MIDLAND ENERGY CENTER PROJECT GWO 7020  
MIDLAND SOILS TELECON OF JUNE 30, 1983  
File: 0485.16 UFI: 42\*05\*22\*04 Serial: 23706  
12\*32

A telecon was arranged between the participants listed below on June 6, 1983 to discuss Consumers Power Company's request for NRC authorization to use the Utility Access Tunnel (UAT) as a means of constructing Piers CT1 and 12. Utilizing the UAT allows loading of CT1 and CT12 prior to removing the soil from KC-4 to KC-5 and from KC-9 to KC-8. This approach was earlier presented to the Case Load Forecast Panel, NRC Region III and NRR. The purpose of this telephone conversation was to review the details with the staff.

(3) SHEETS OF SKETCHES ATTACHED TO THIS REPORT.

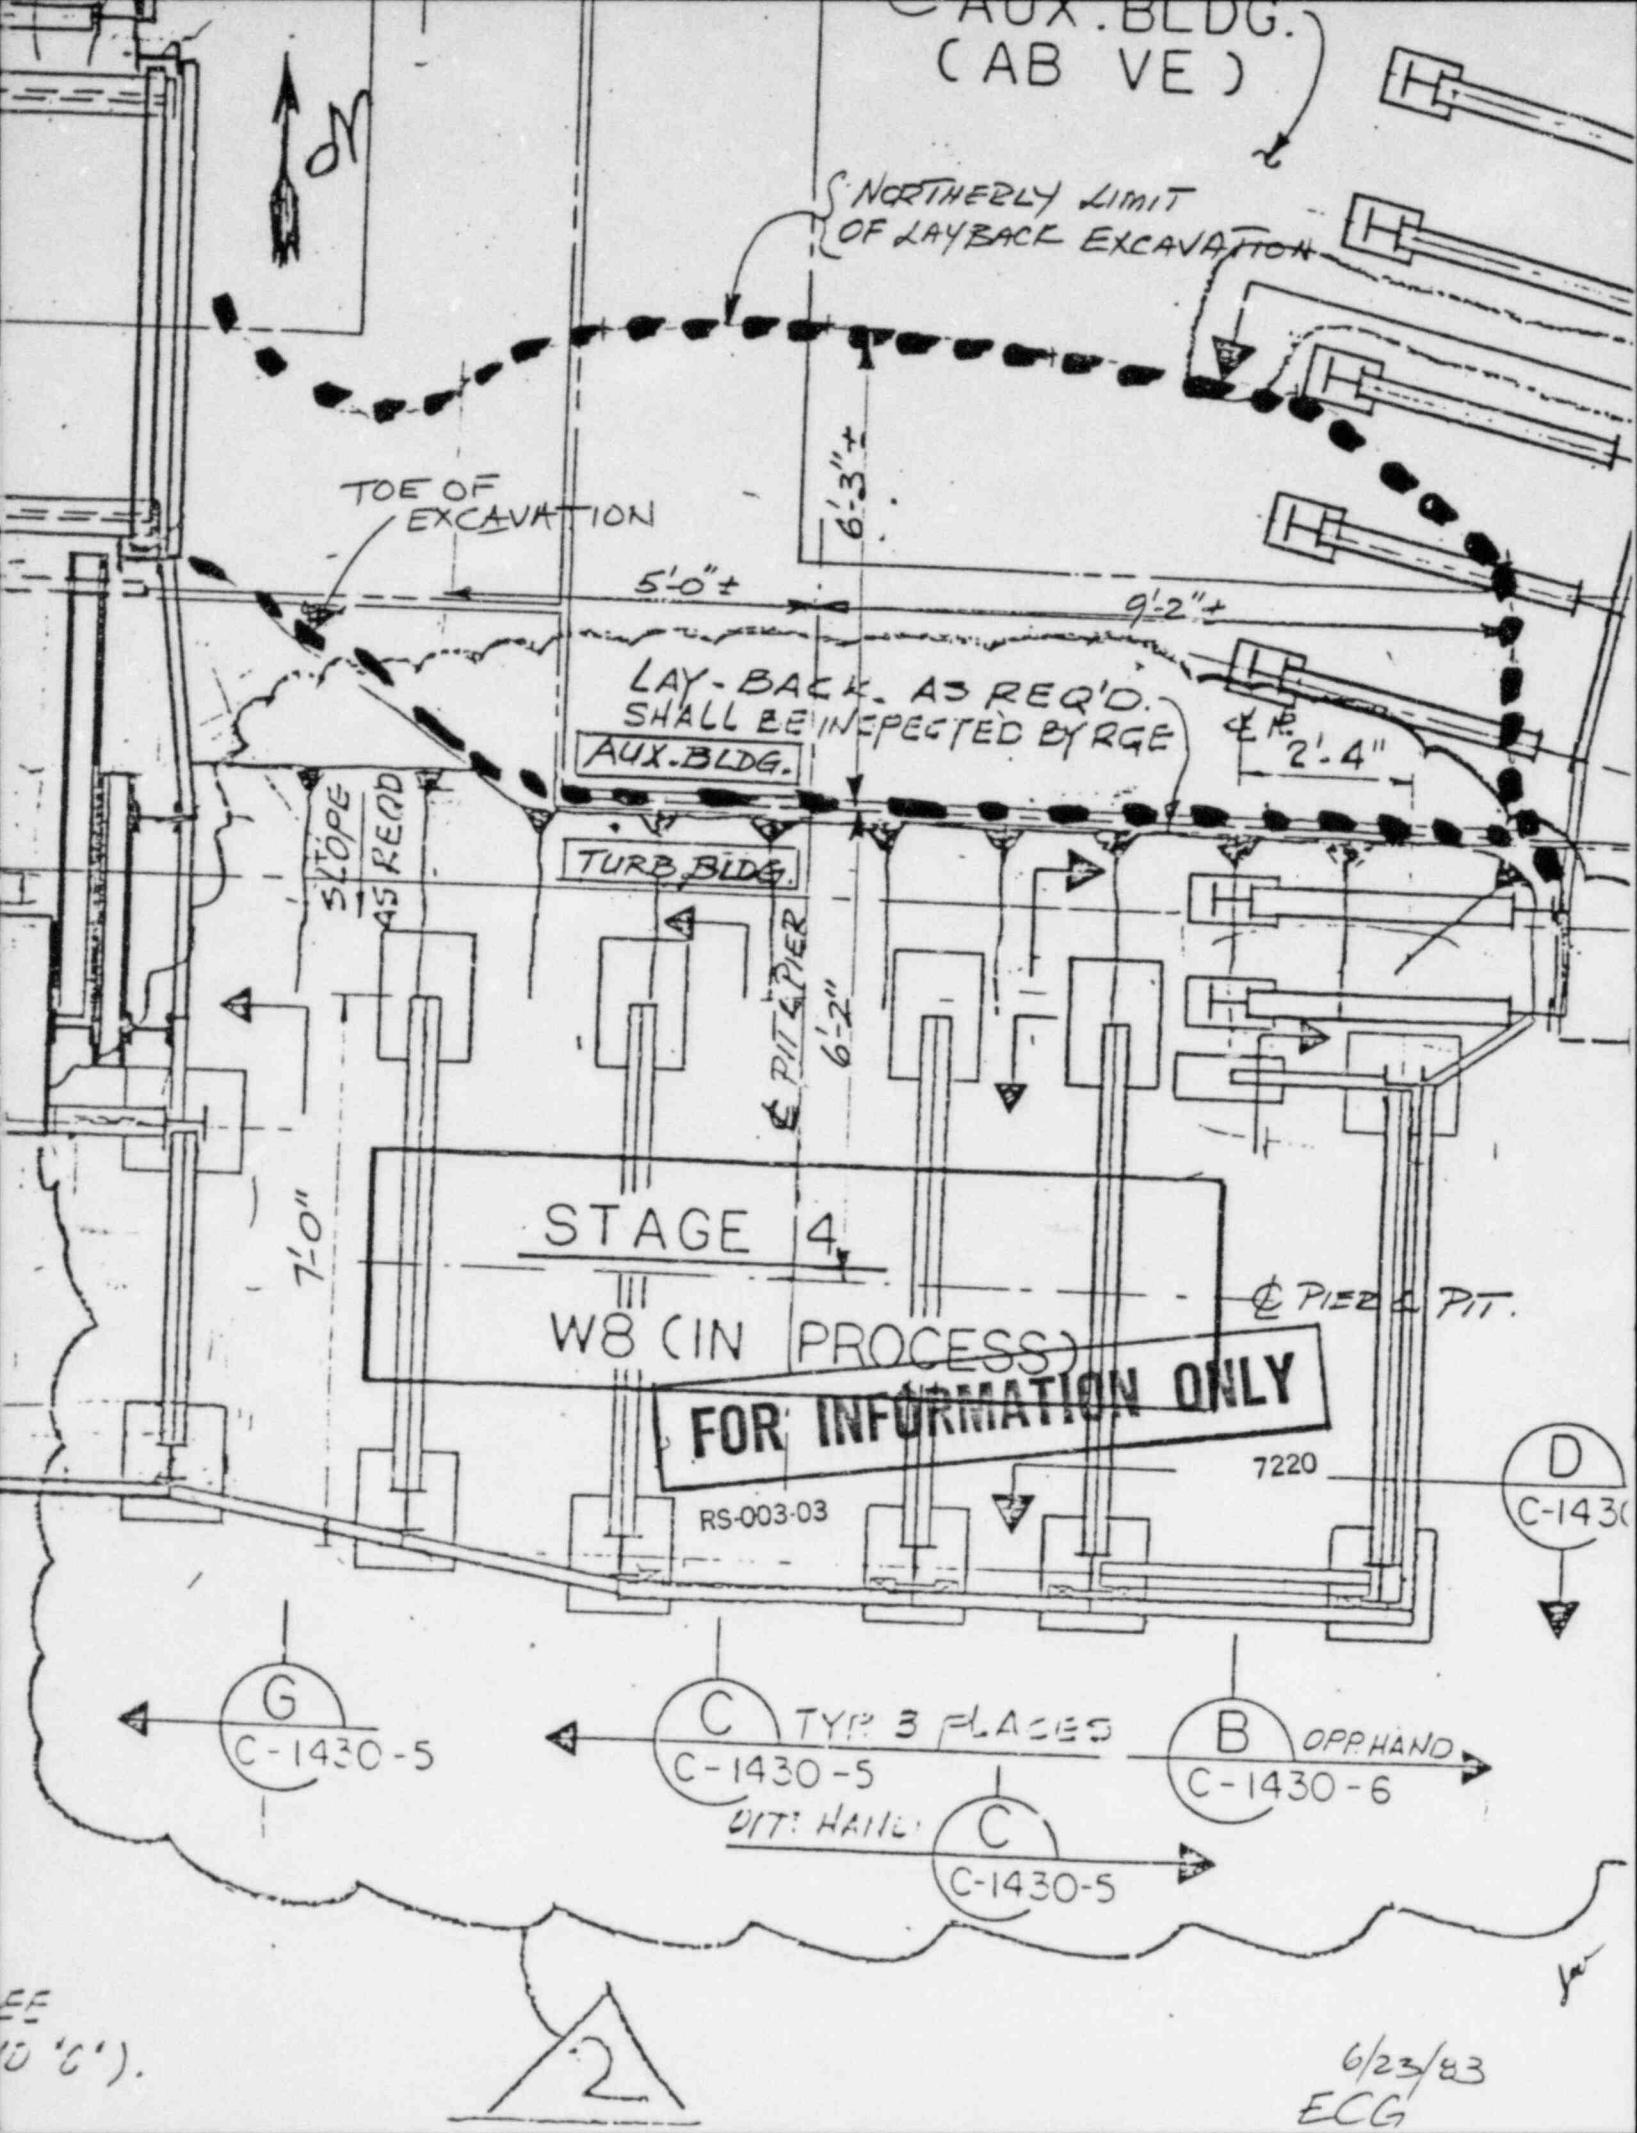
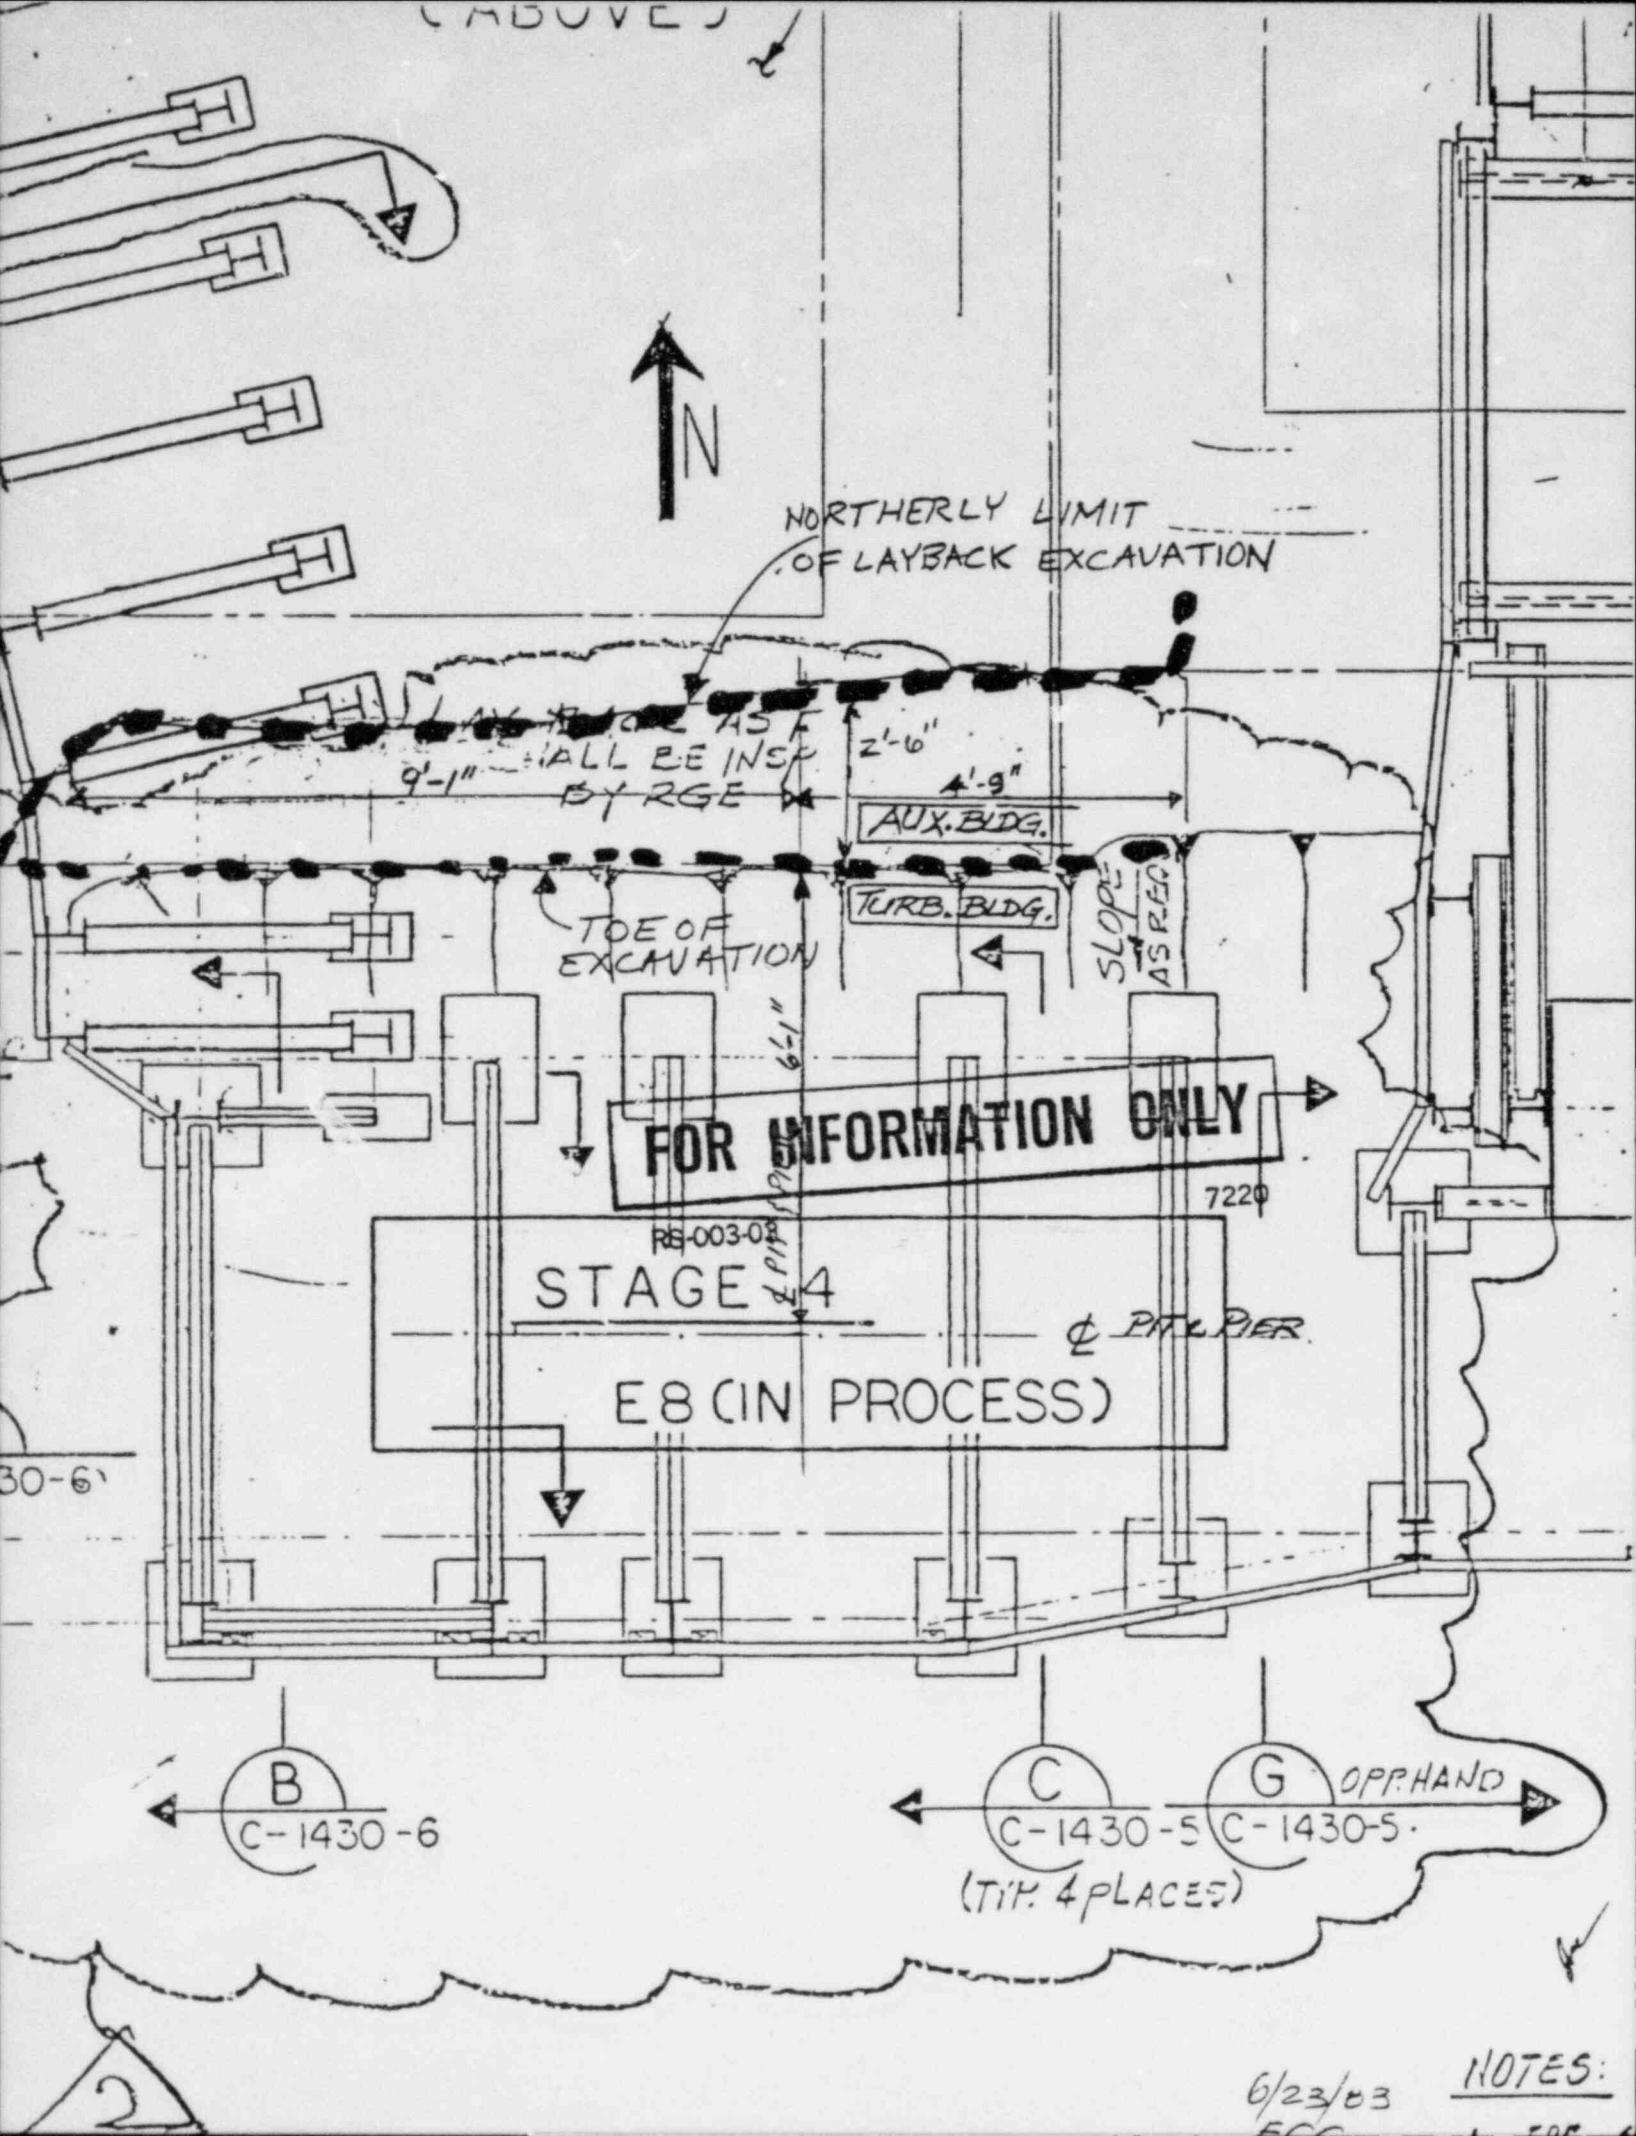
| (15)   | RGE (R. CORY & F. GRAY) COMPLETED PREPARATION OF "AS BUILT" EXTENT OF EXCAVATIONS UNDER AUX RIDG ALONG THE NORTH SIDE OF ACCESS DRIFTS TO PIERS E-8 & W-9. TODAY SKETCHES WERE PREPARED   |         |
